**MONTGOMERY COUNTY DEPARTMENT OF PARK AND PLANNING**

**MEMORANDUM**

**SUBJECT:** Mandatory Referral No. 06102-MCPS-1: New Hampshire Estates Elementary School (Access and Safety Improvements) – 8720 Carroll Avenue, R-60 Zone, East Silver Spring Master Plan

Attachment 3: Existing Conditions

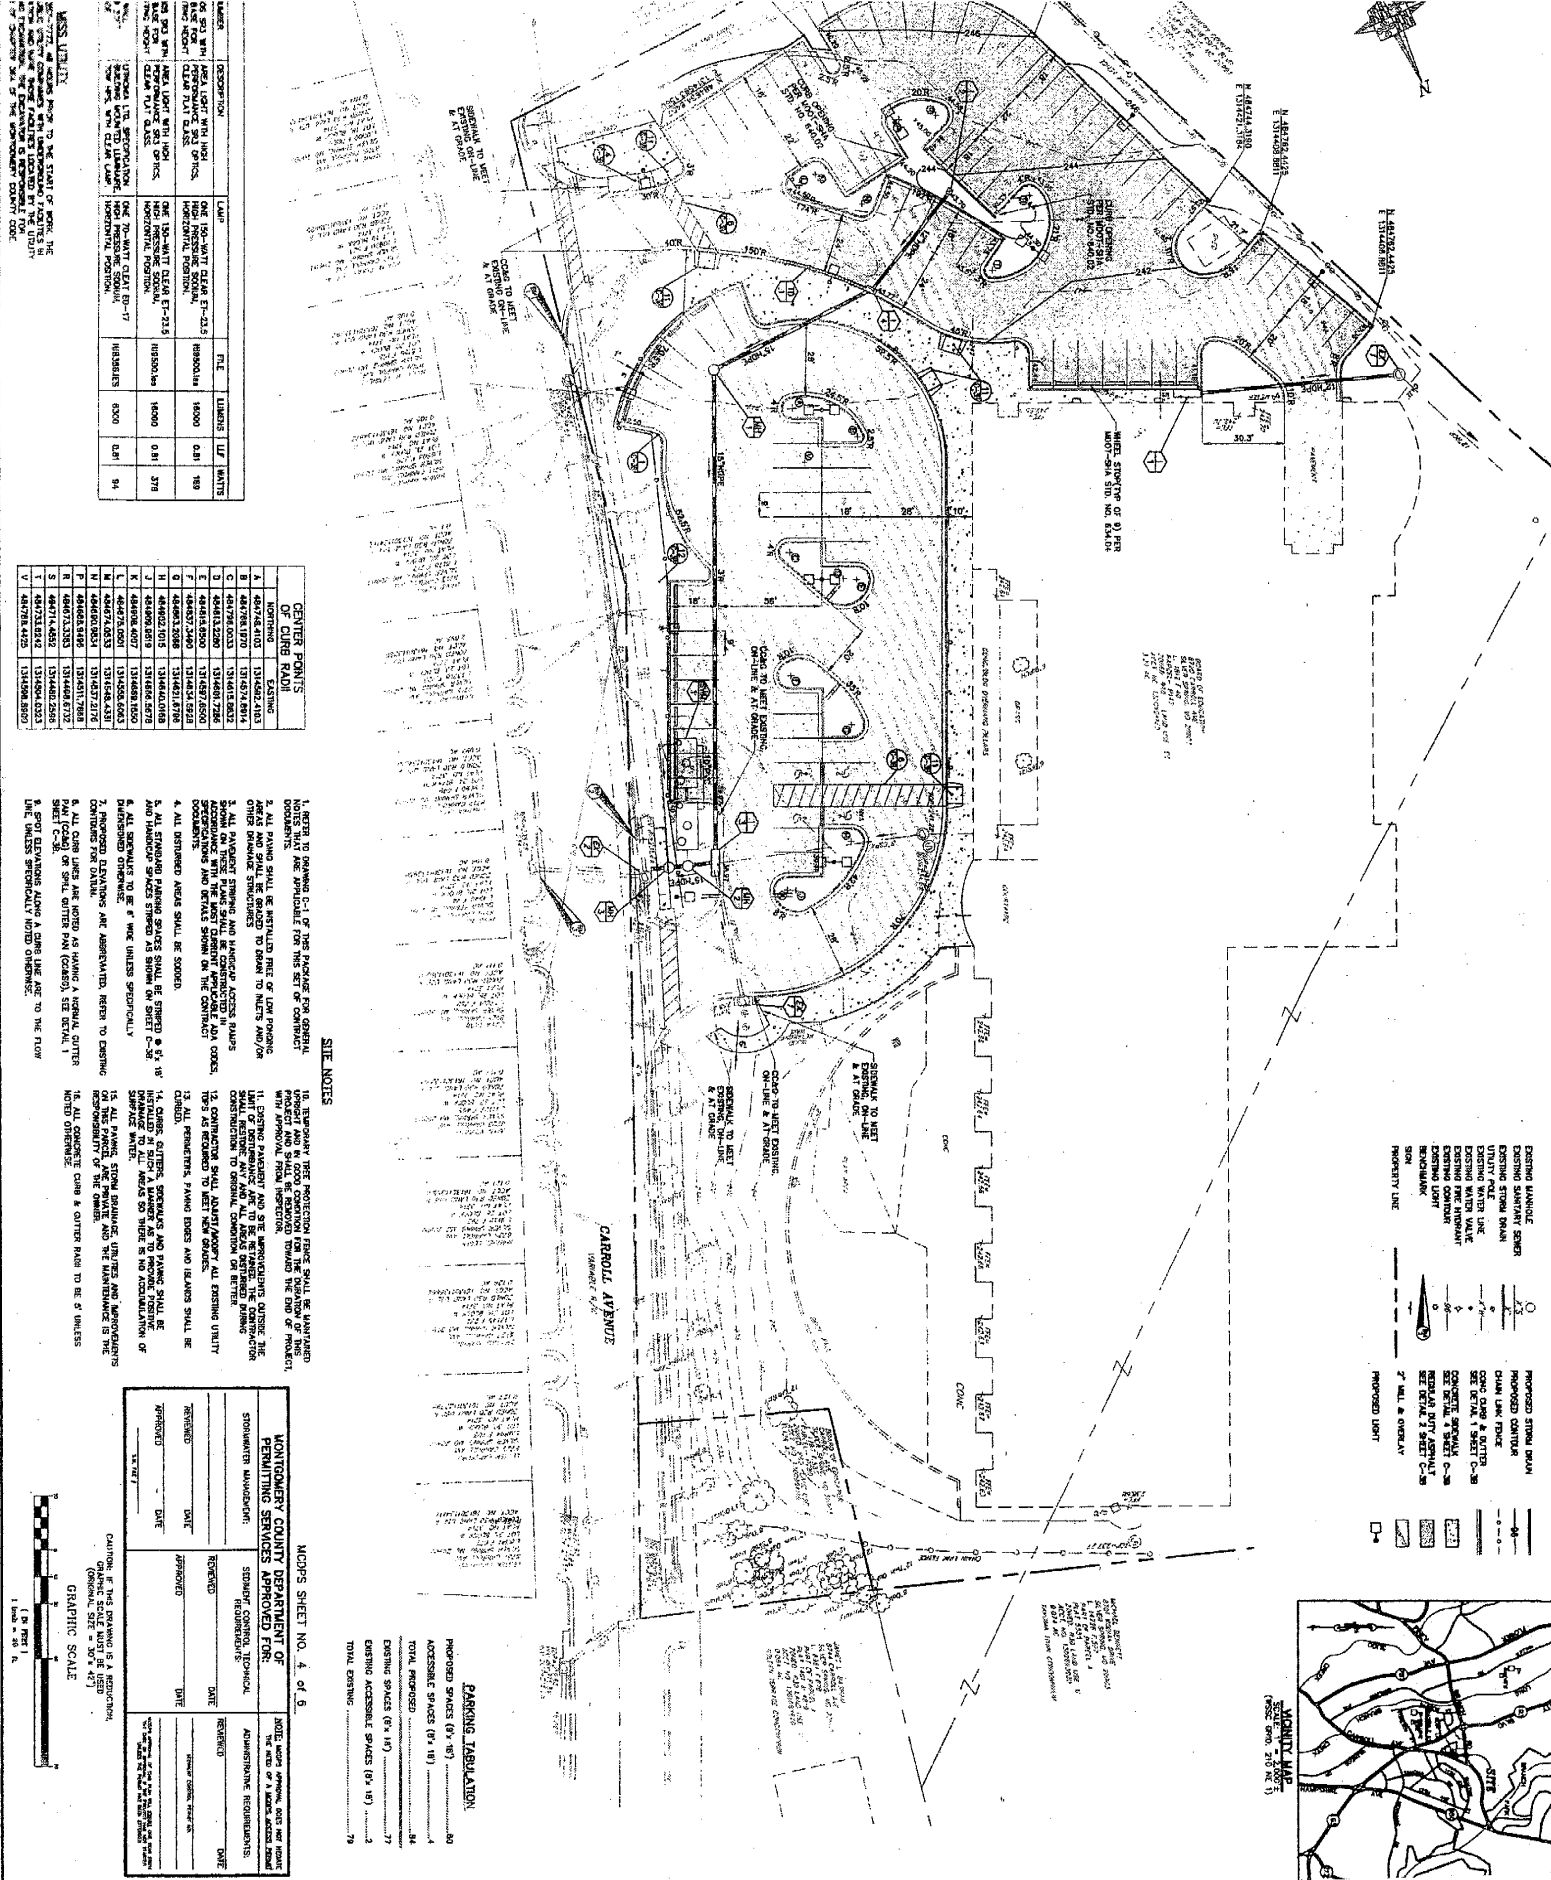
1. Prohibit outbound left turns during peak arrival and departure times (8:00-9:00 a.m.) from the parent/staff access driveway.
2. Widen the sidewalk along Carroll Avenue at the school's northern driveway to accommodate student pick-up/drop-off activities.

3. Relocate and reconfigure the proposed auxiliary boarding area for Oakview Elementary students to the front of the school along Carroll Avenue north of the parent/staff access driveway. Connect boarding area with sidewalk along Carroll Avenue.

4. Eliminate the proposed pedestrian crosswalk across the parent/staff access driveway.
5. Develop and distribute informational packets for parents and teachers in advance of proposed changes in on-site traffic access and circulation.

- ***Prohibit left-hand turns from the parent/staff access driveway during morning drop-off periods to reduce the potential for conflict*** – In creating two full-service driveways within close proximity of each other (240 feet), the amount of conflicting vehicle movements increases and provides the crossing guard with more responsibilities than she currently possesses.

- ***Require Oakview Elementary school students to be picked-up/dropped-off on the northern side of the parent/staff driveway and reconfigure waiting pad*** – The MCPS proposal recommends that the Oakview Elementary School students be picked up/dropped off in the southeast corner of the parent/staff parking lot, away from the general student pedestrian crosswalk area. Staff finds that moving the loading area to the northern side of the driveway and extending the waiting area to the existing sidewalk on Carroll Avenue, would provide the buses with an easier access point to load and unload students than at the previously proposed location.

- ***Remove the proposed angled crosswalk in the driveway of the parent/staff parking area*** – Staff finds that the presence of two crosswalks approximately 100 feet apart within the parent/staff parking area is confusing and redundant. Staff recommends eliminating the angled crosswalk and maintaining the existing single crosswalk at the entrance of the parent/staff parking area. This single location for pedestrians to cross the driveway is suitable.

- ***Extend proposed sidewalk on the northern approach of the entrance to the bus/staff parking lot*** – Staff noticed considerable pedestrian activity concentrated at the northernmost corner of the entrance driveway (near the crossing guard station). Additional sidewalk width and maneuvering space would be beneficial.
- ***Educate staff, parents, and students on appropriate traffic/pedestrian activities during arrival and departure times*** – Staff recommends that all users of the site be informed, in writing, about the new circulation patterns anticipated in this proposal.
